MYALL RIVER DOWNS PTY LTD
MYALL RIVER DOWNS
WATER MANAGEMENT REPORT

Appendix 3 - WorleyParsons' Response to BMT WBM Review of Draft Water Management Strategy (3rd March 2009)

MYALL RIVER DOWNS, TEA GARDENS - RESPONSE TO REVIEW OF FLOODING, STORMWATER AND GROUNDWATER ASSESSMENTS

APPENDIX A – ADDITIONAL INFORMATION

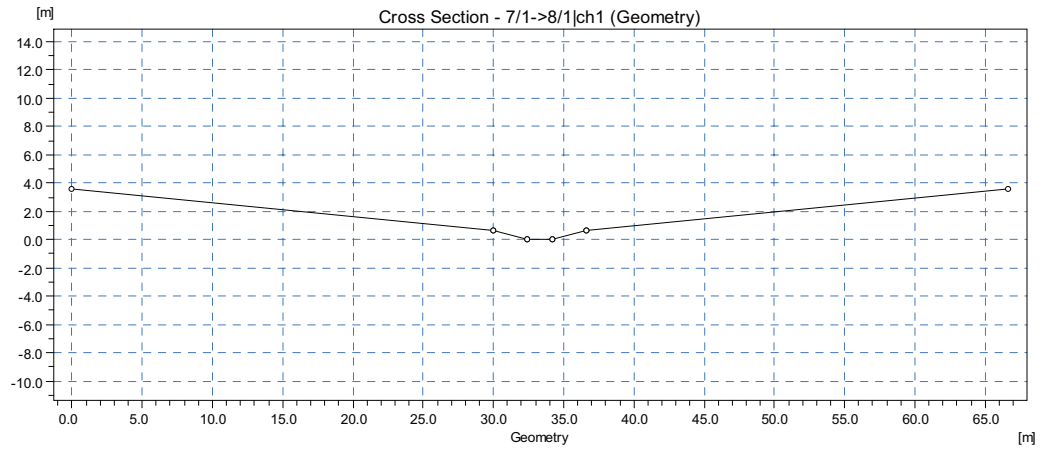
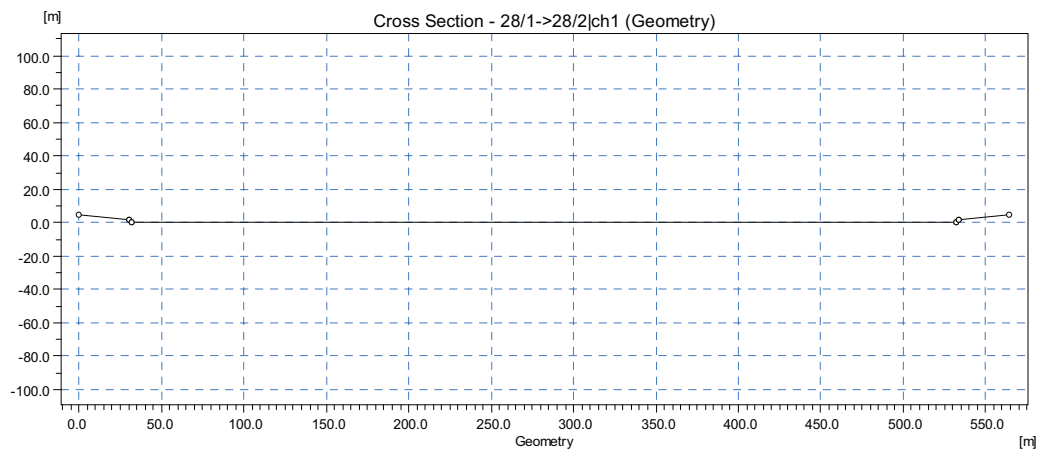
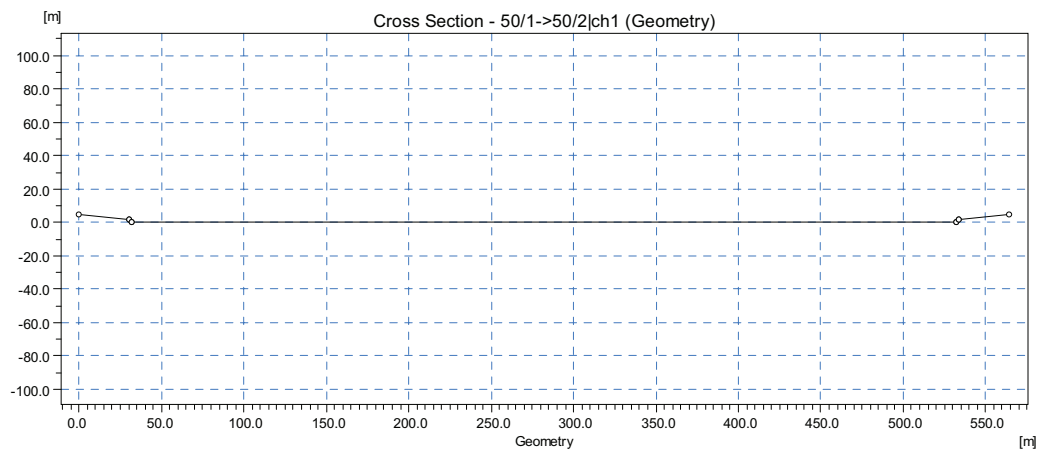
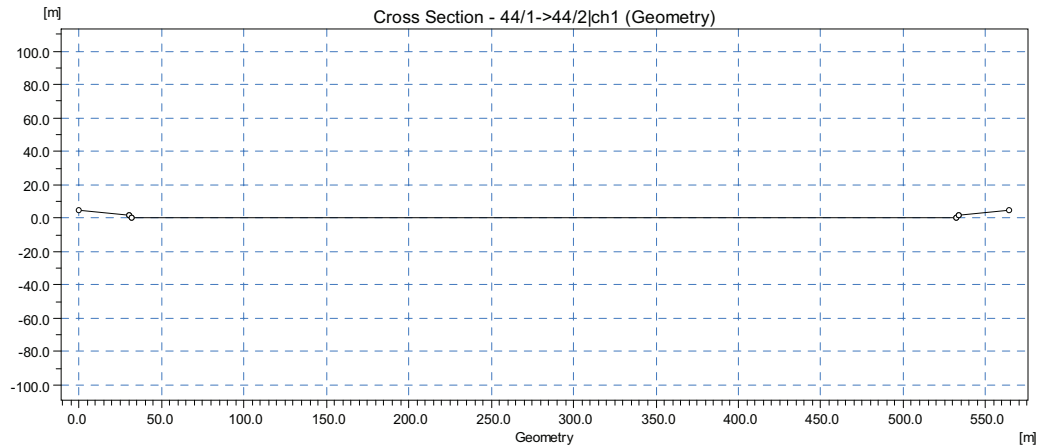
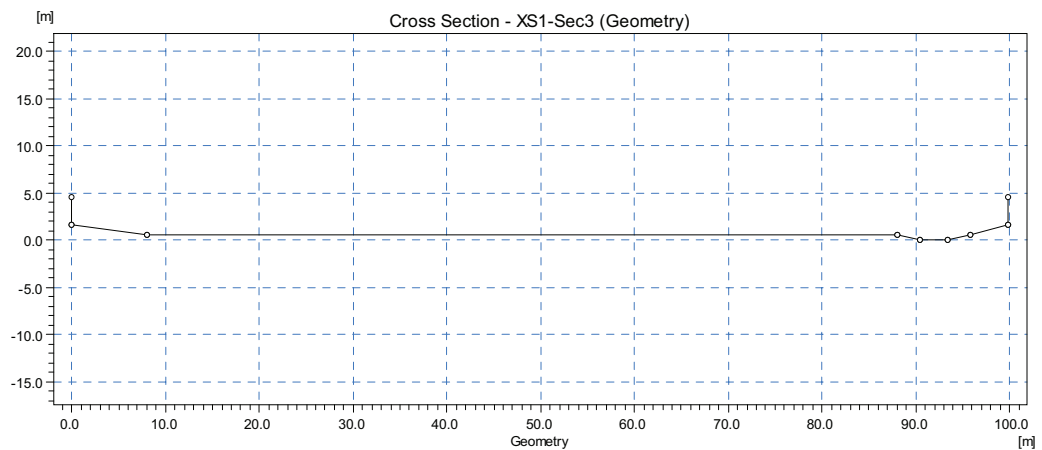
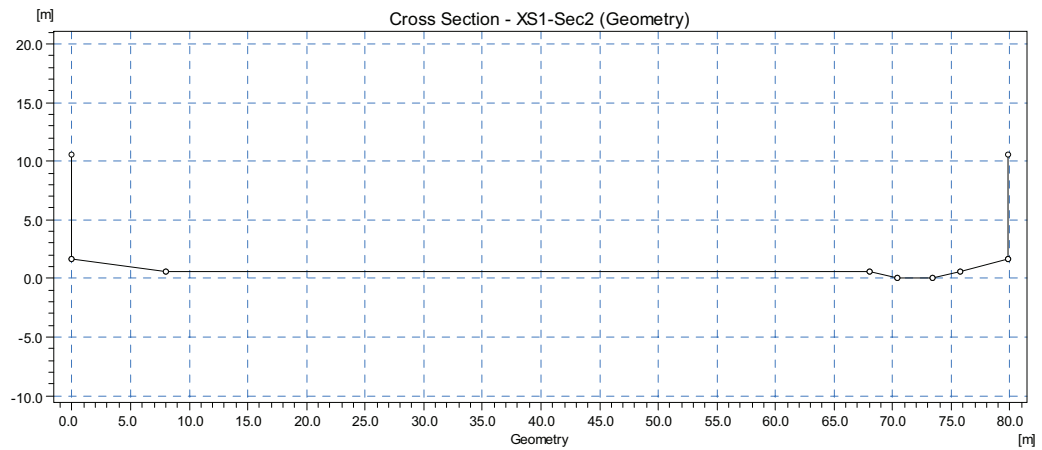
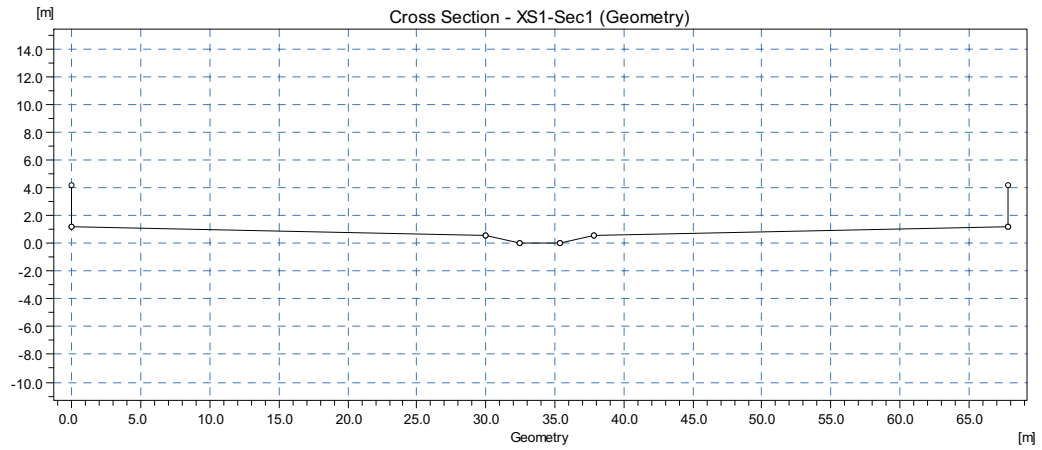
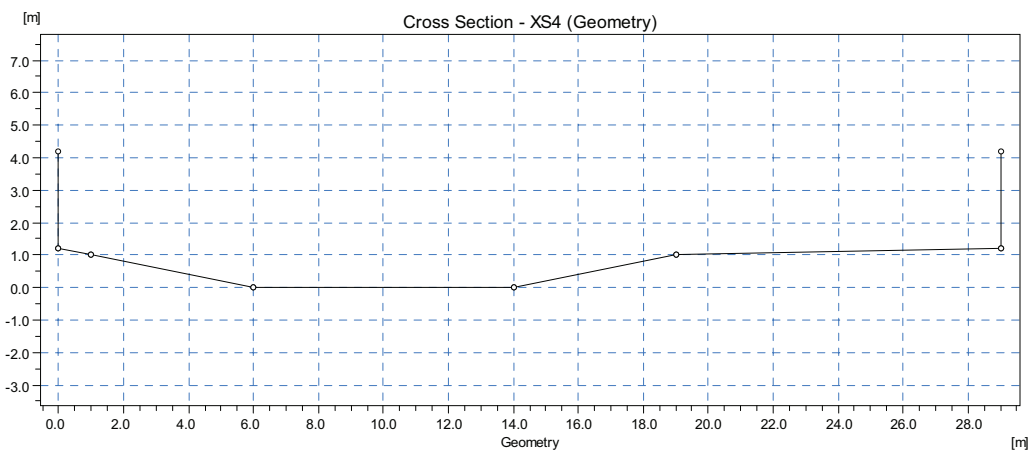
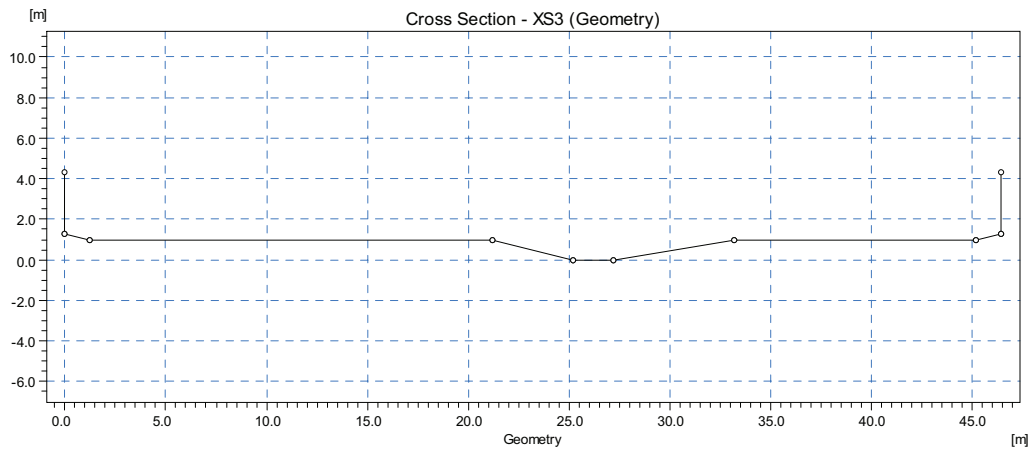
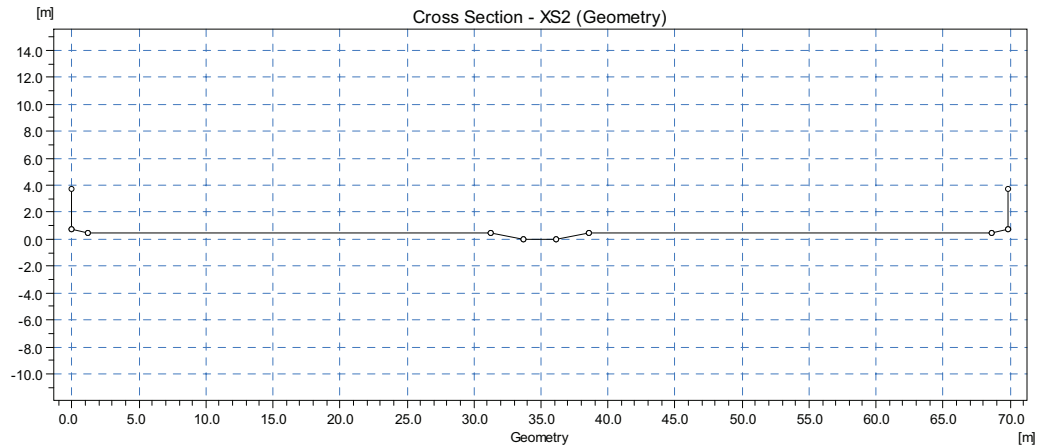
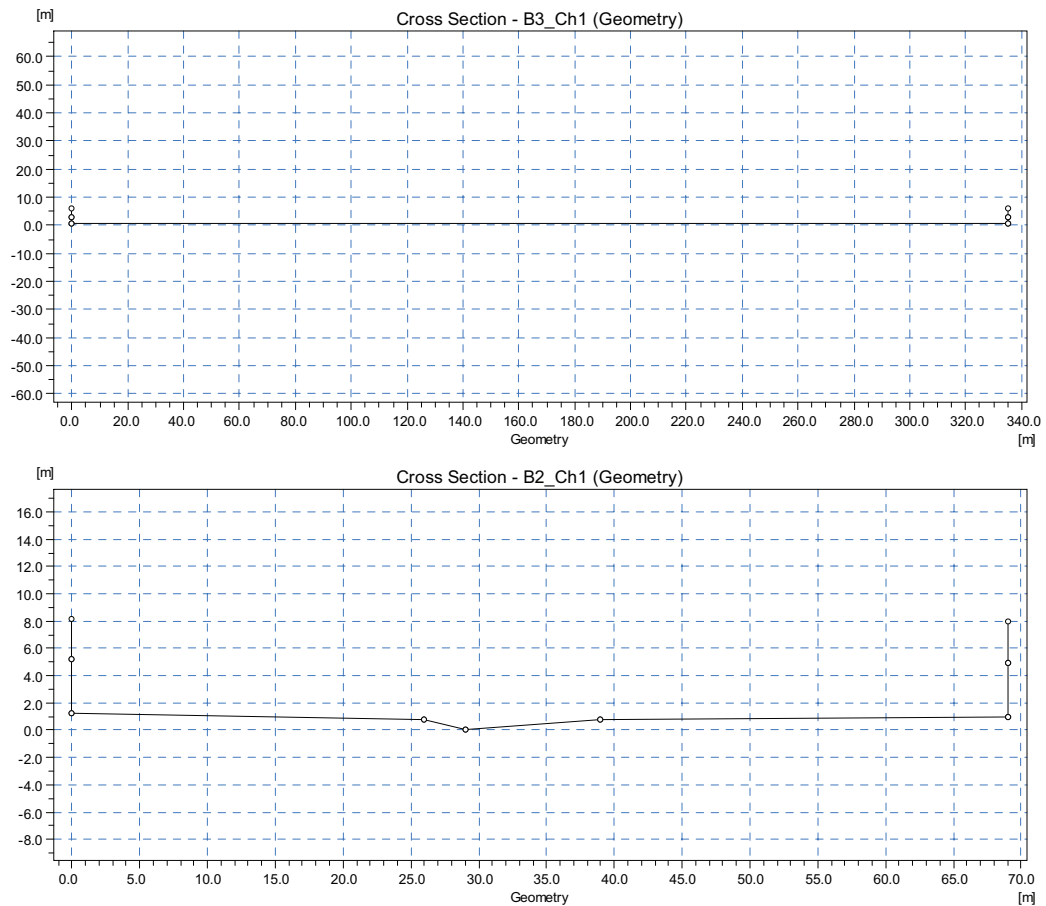
16. Limited information is provided in the report regarding the dimensions of the modelled channels. Depths and side slopes are provided, but no details on the modelled widths are provided. The report indicates that 'channel widths were estimated from the masterplan'. It is considered that this information should be provided in the report.

Channel geometry is provided below.

Long section of western branch

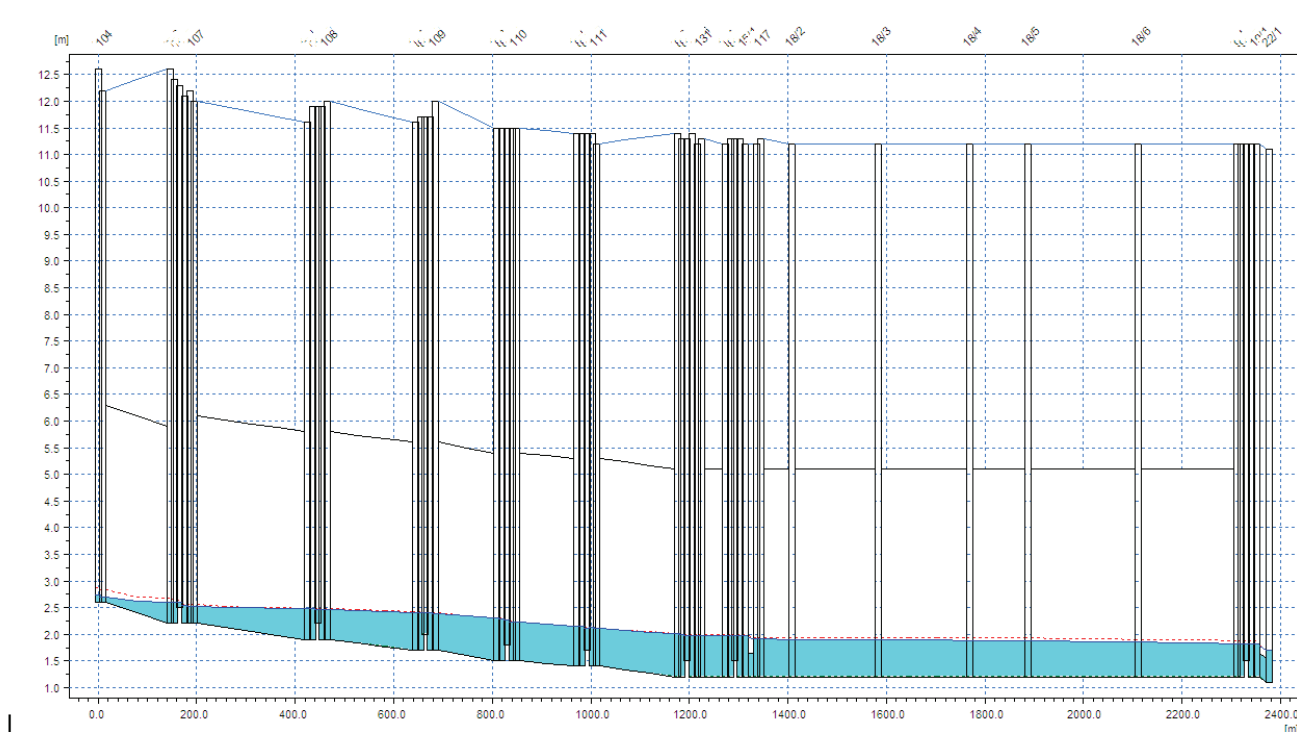
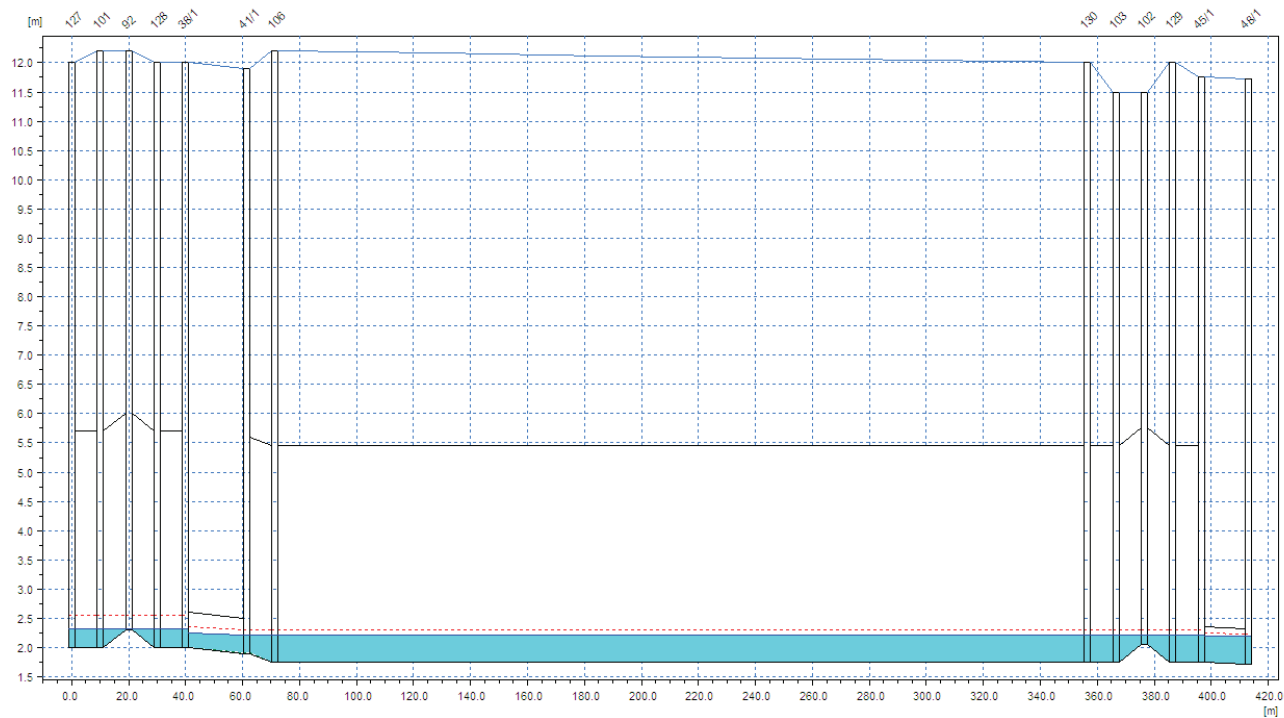
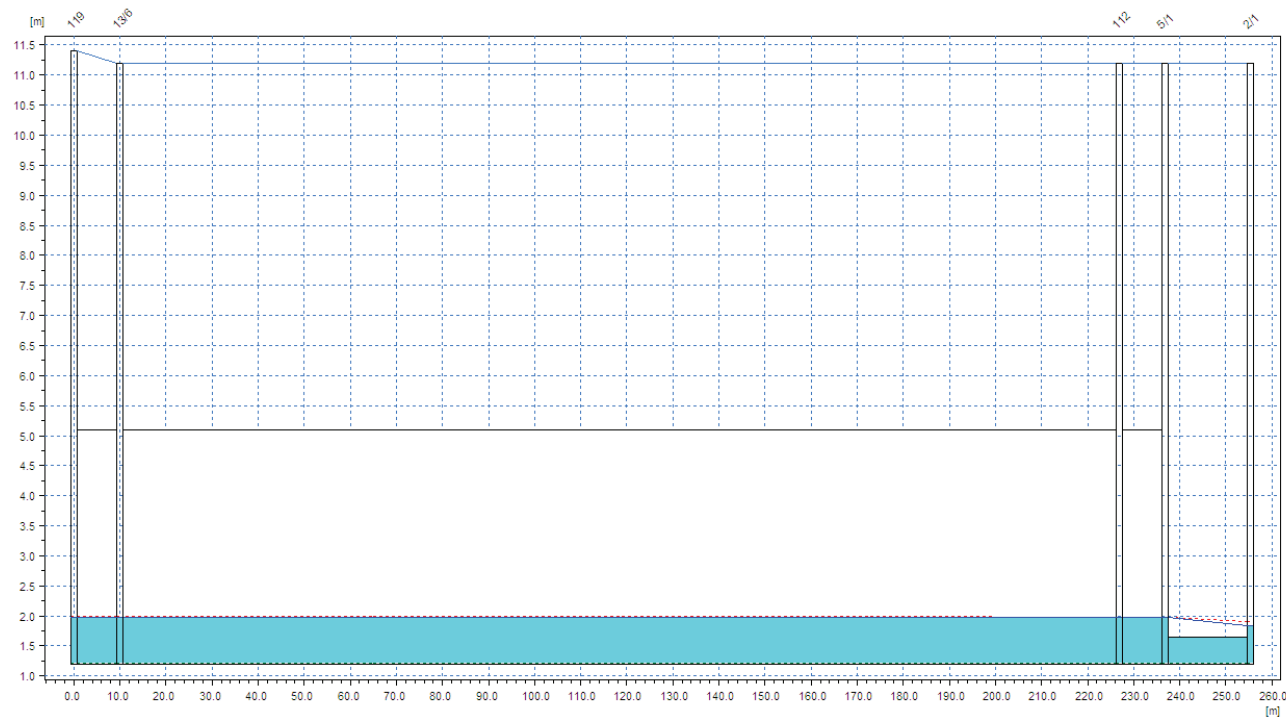
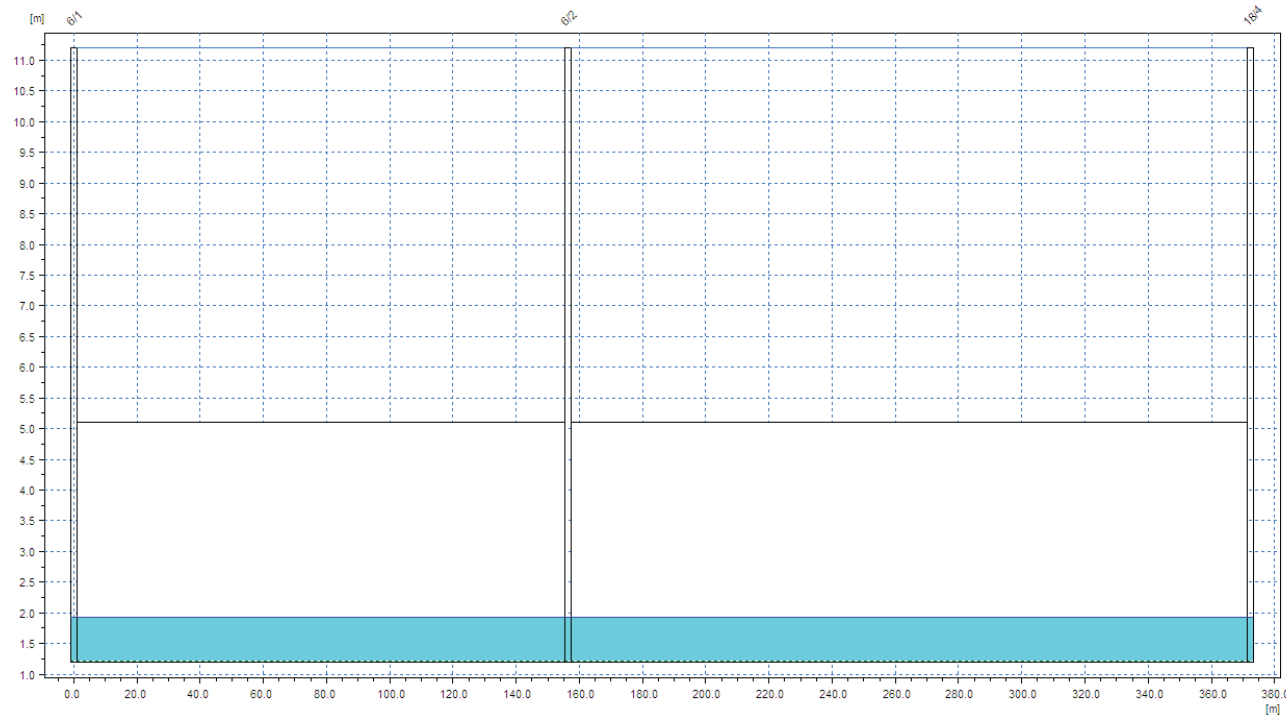
17. Constructed wetlands are proposed to be formed within the invert of the main channel. The constructed wetlands were modelled in MUSIC with a 1m deep permanent storage and 0.3m deep extended detention storage. Based on Diagram 2.4 presented in the WP report, it appears that provision of the constructed wetlands within the main channel has not been incorporated into the hydraulic models.

Long sections of the revised model are provided in **Appendix A**.
